HISTORIC PRESERVATION BOARD AGENDA
April 18, 2018 at 5:00 p.m.
Room 209, City Hall, 389 Congress Street

**WORKSHOP – ADVISORY REVIEW
222 ST. JOHN STREET**

**WORKSHOP
392 SPRING STREET**

NORTH

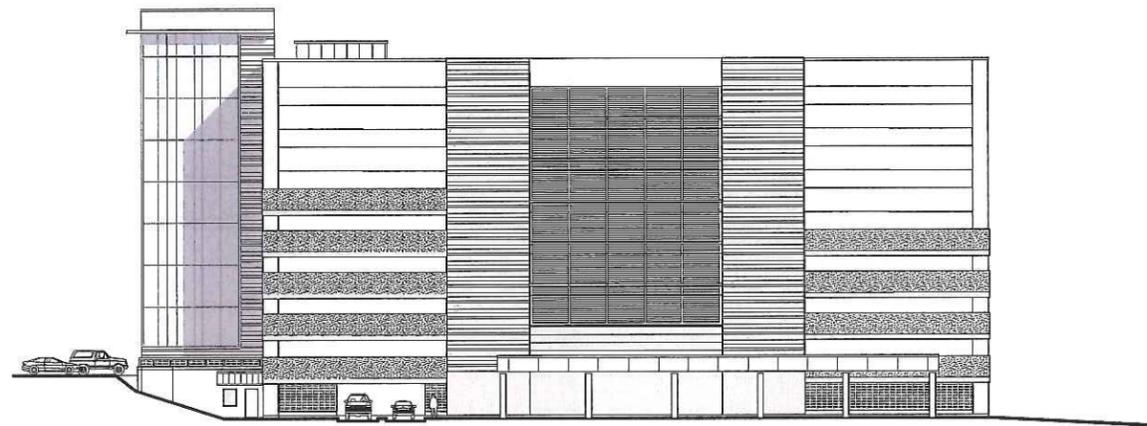
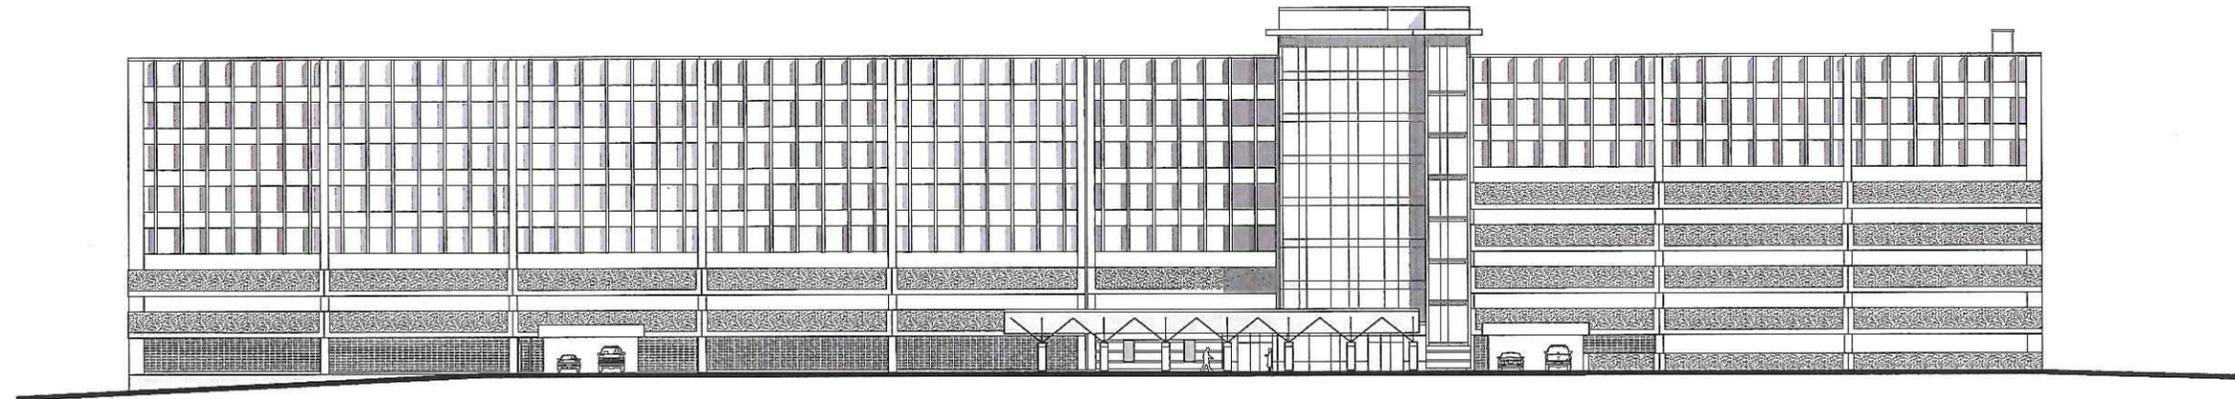
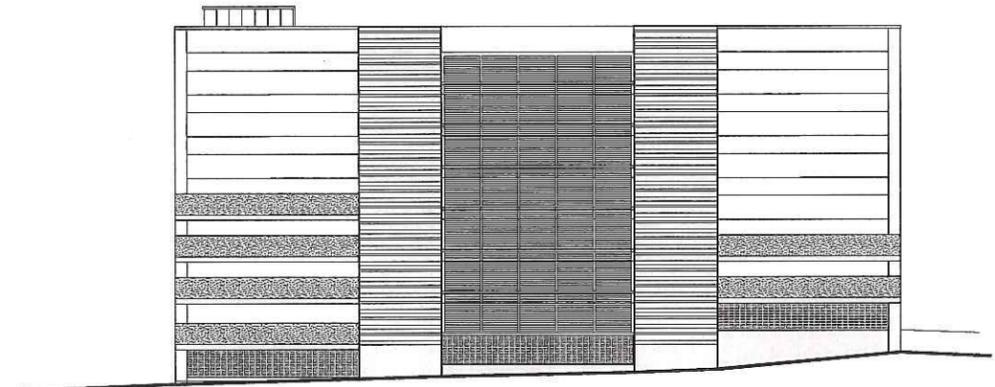
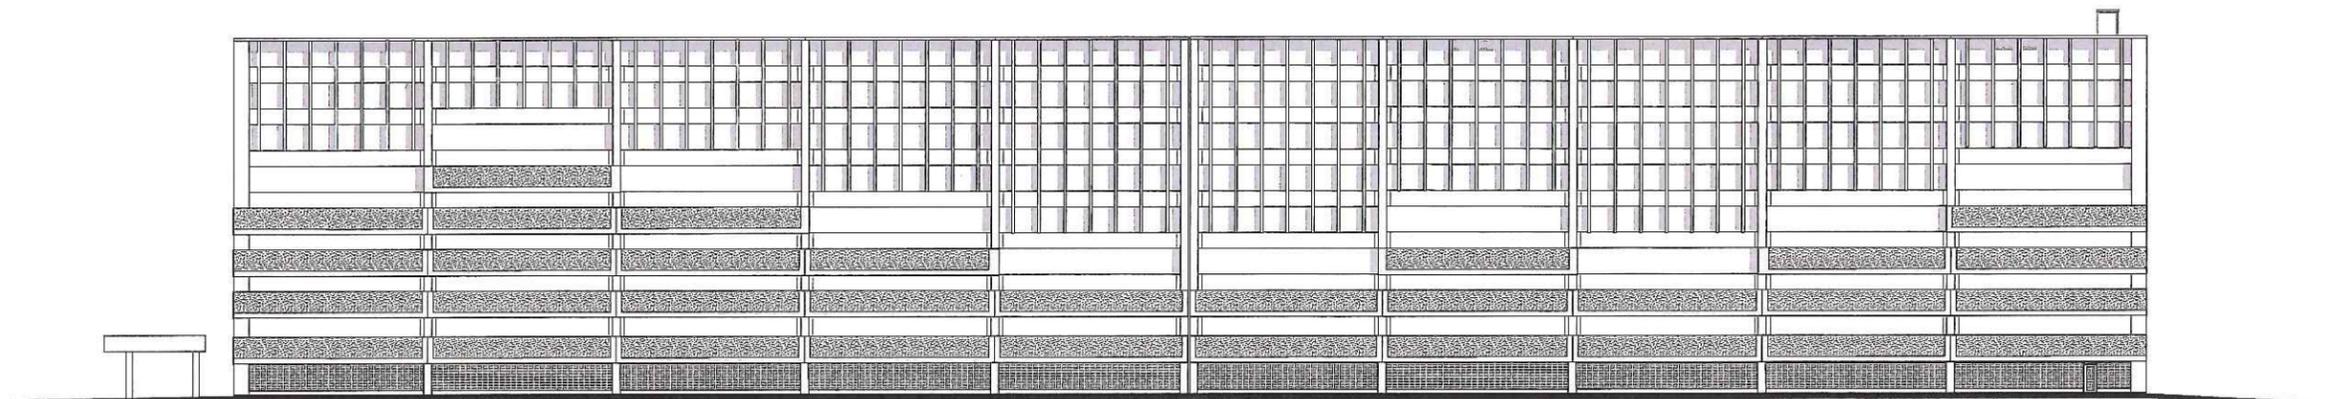
*Given the fact that the north elevation of the garage will have the most direct visual relationship with the MCRR office building, how does the new structure relate to the rear elevation of the historic structure? Are there ways that the two elevations might better relate?

DRUCE REAR ELEVATION - EXISTING PHOTOS AND PROPOSED ELEVATION

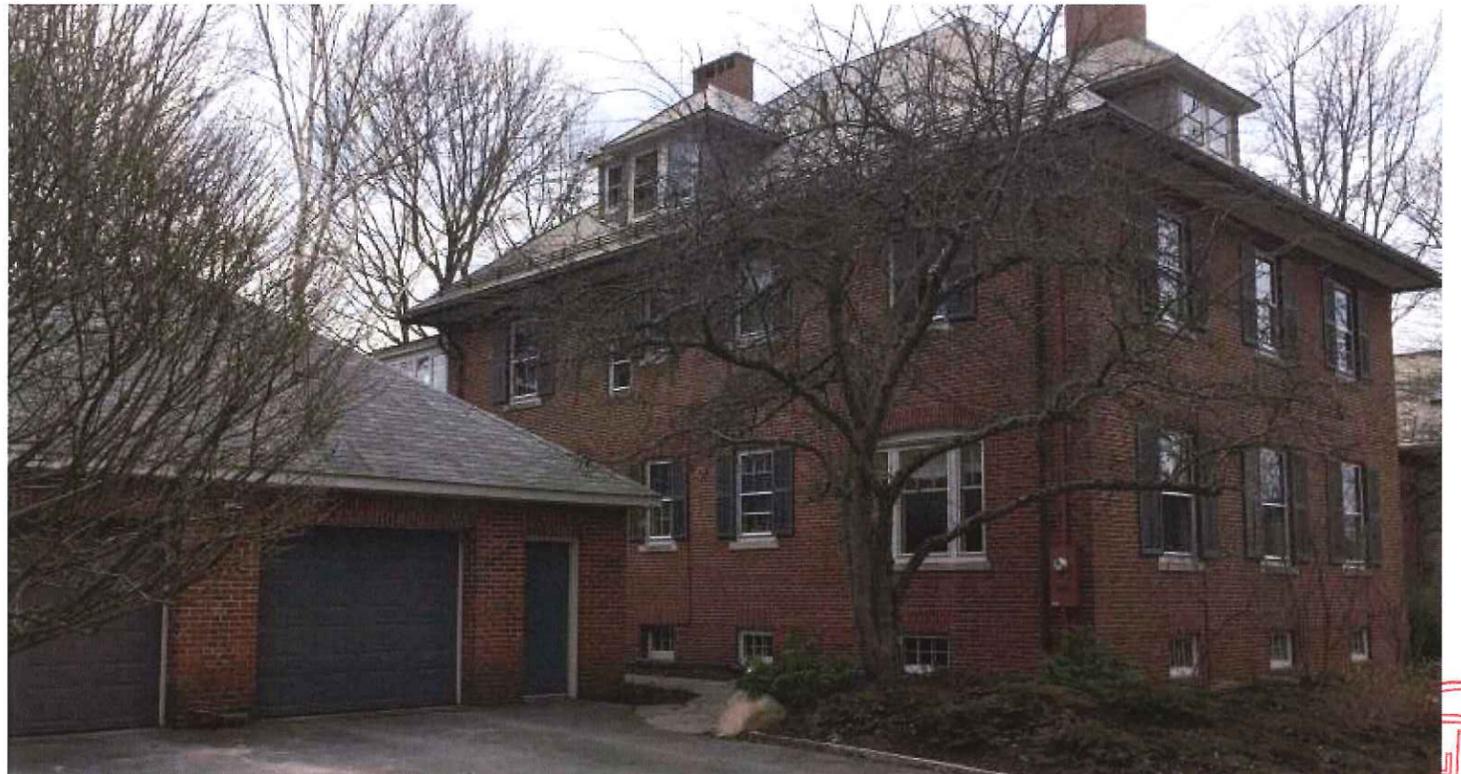
- Staff is comfortable with the fact that the new rear addition will appear more solid and substantial than the existing one, with less glass on the more visible second floor, and more grounding below, thanks to a solid first floor instead of the existing posts.
- The Board will no doubt discuss the choice of simulated shingles for the siding on the second floor. Though shingles are present on the sides of the third floor dormers, and despite the visual interest they might impart, in the case of the addition walls the whole addition might be quieter without the change of material from the grey siding proposed for the lower walls.

DRUCE SIDE ELEVATION WITH PROPOSED MUDROOM

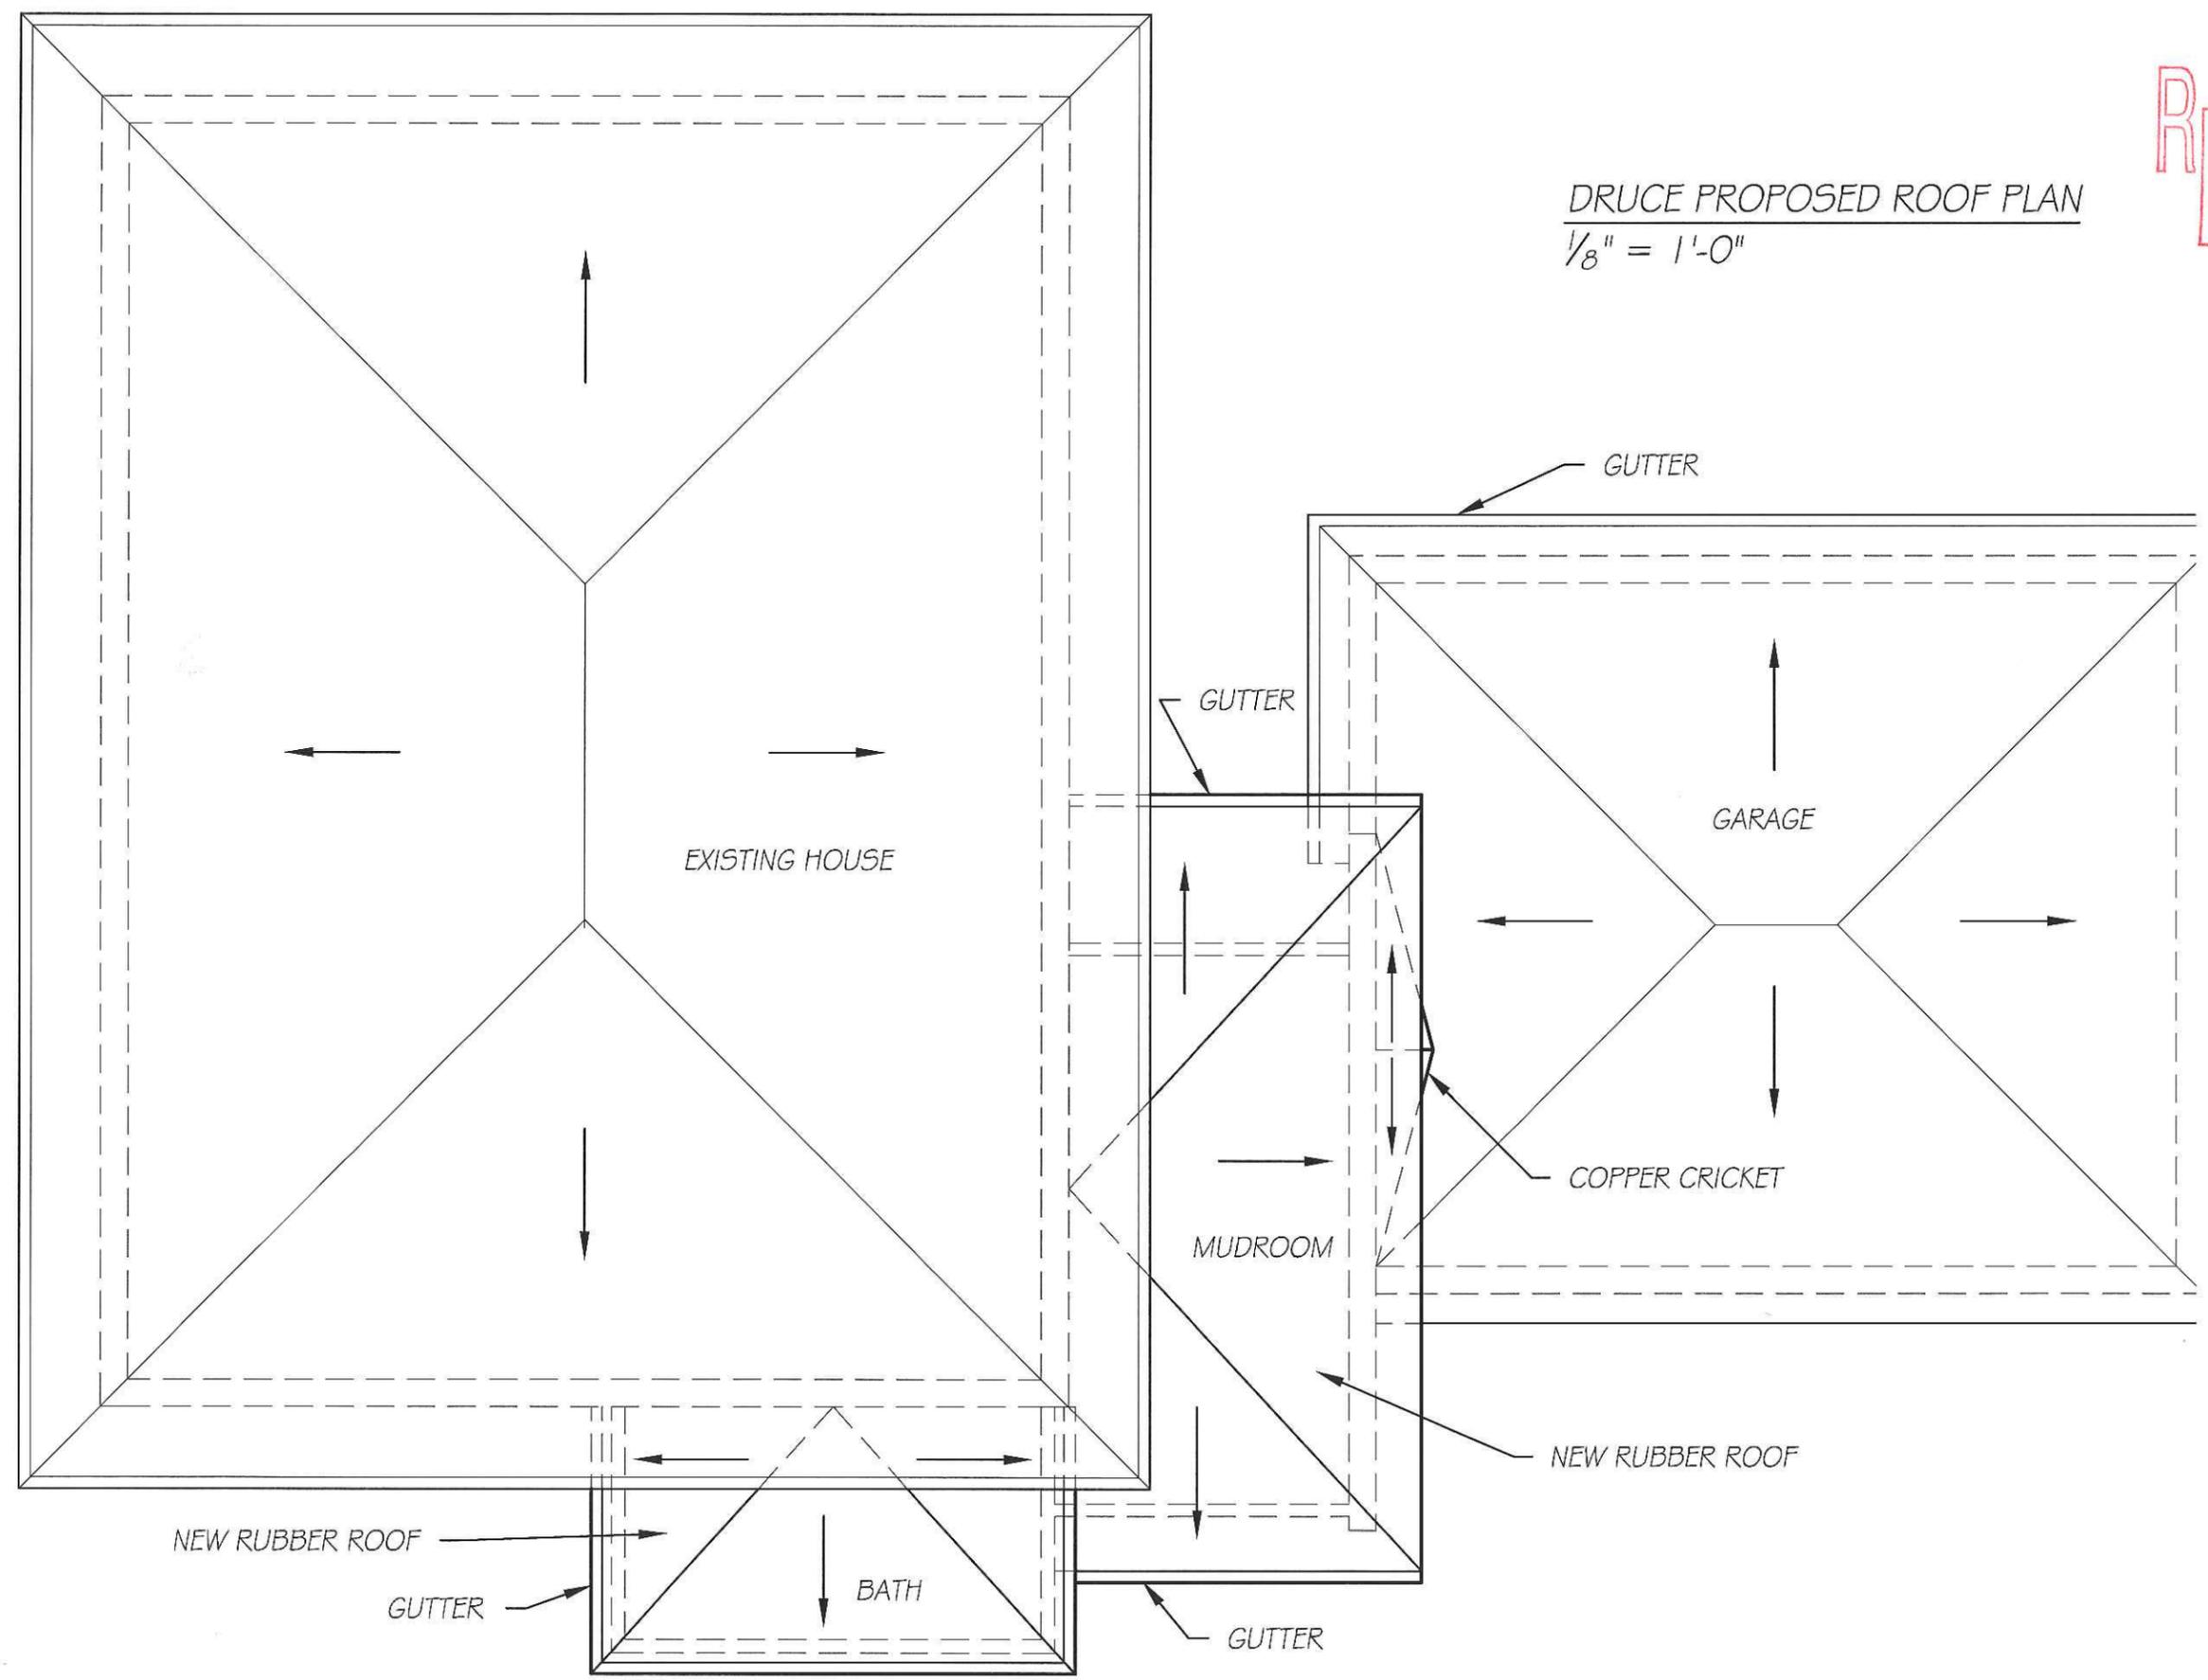
- Staff questions whether the mudroom addition could and should be lowered, to make it less substantial. Though the garage roof requires that the addition have some height, how important are the high ceiling and the transom windows?
- Although it will probably be used more than the front door on the west side of the house, staff suggests this is a utilitarian, secondary entrance – attractive, compatible, differentiated, but not excessively eye-catching, despite its contemporary design.

PROPOSED EXTERIOR ELEVATION _SOUTH

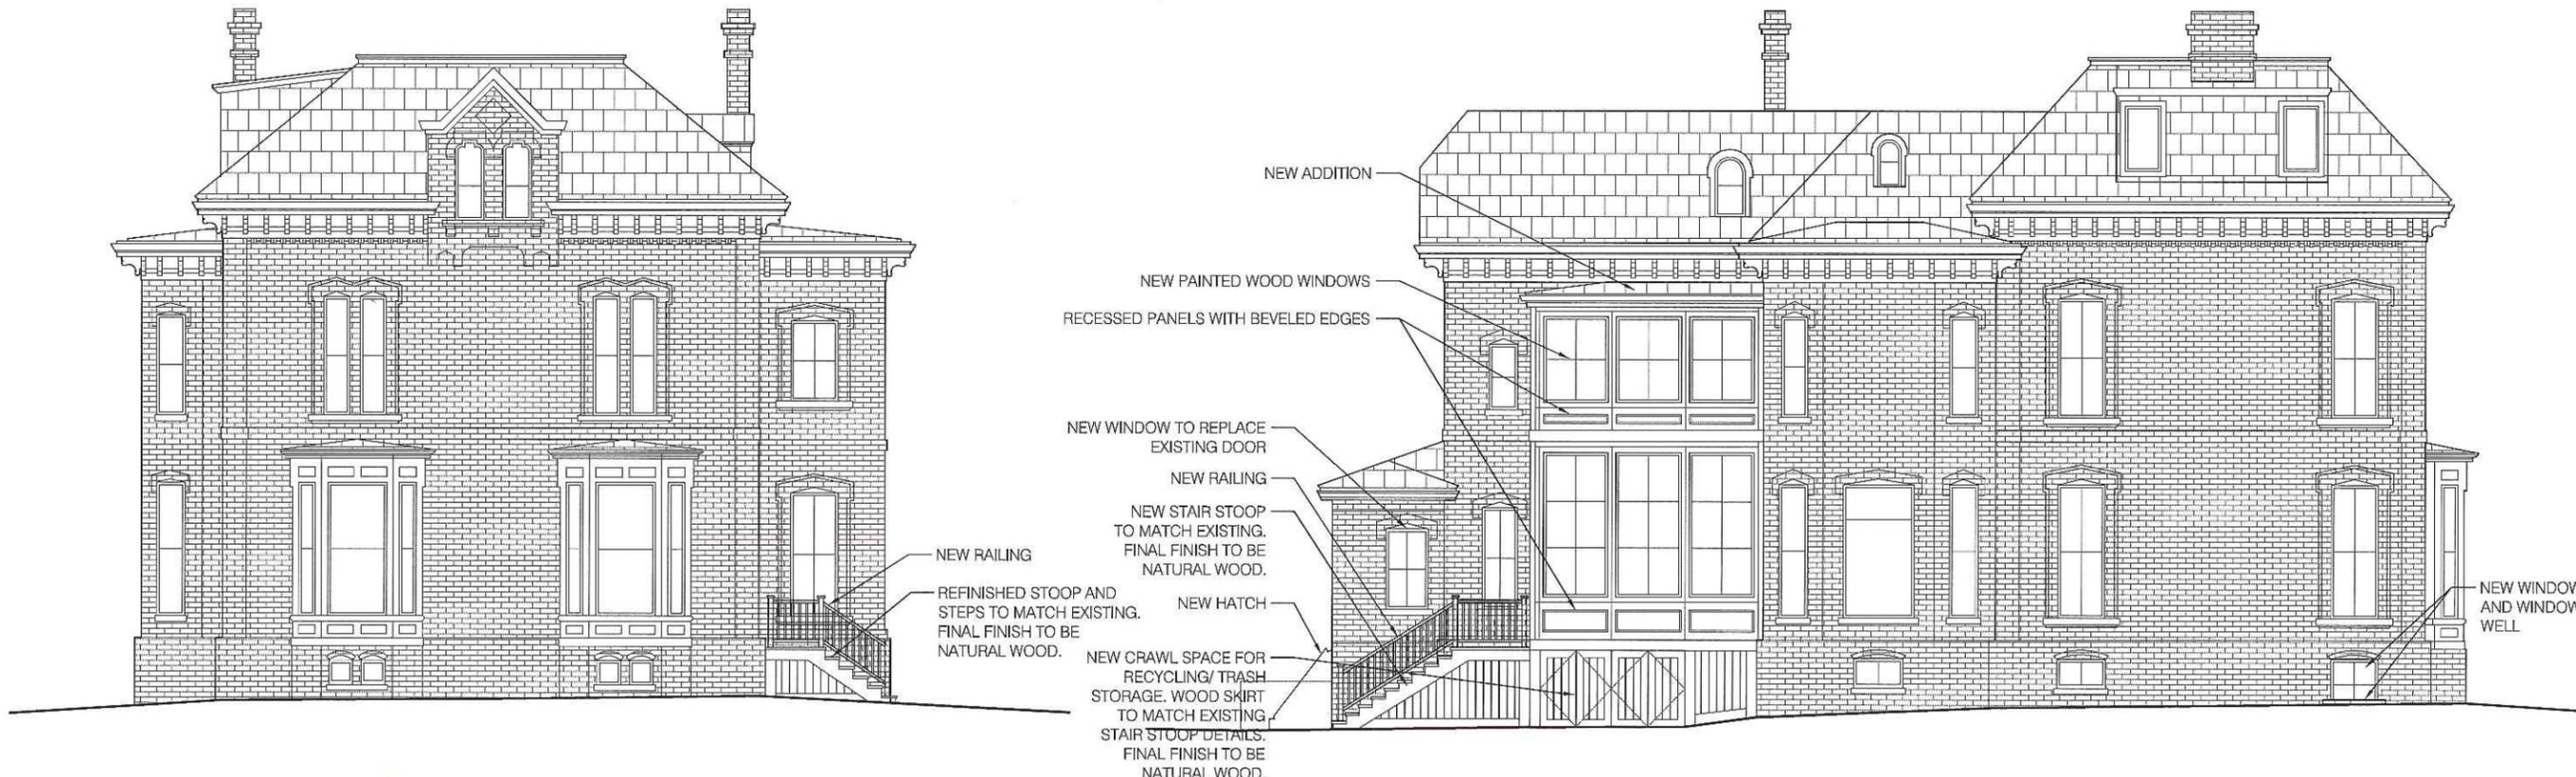
- The proposed porch posts and stair railing at the main entrance on the south elevation do not appear substantial enough for the scale and formality of the house or for a main entrance. Staff would suggest that the posts be beefed up, at a minimum. Perhaps consideration might also be given to incorporating a jigsaw pattern for the railing, which would help "flag" the entrance and provide a higher level of detail.
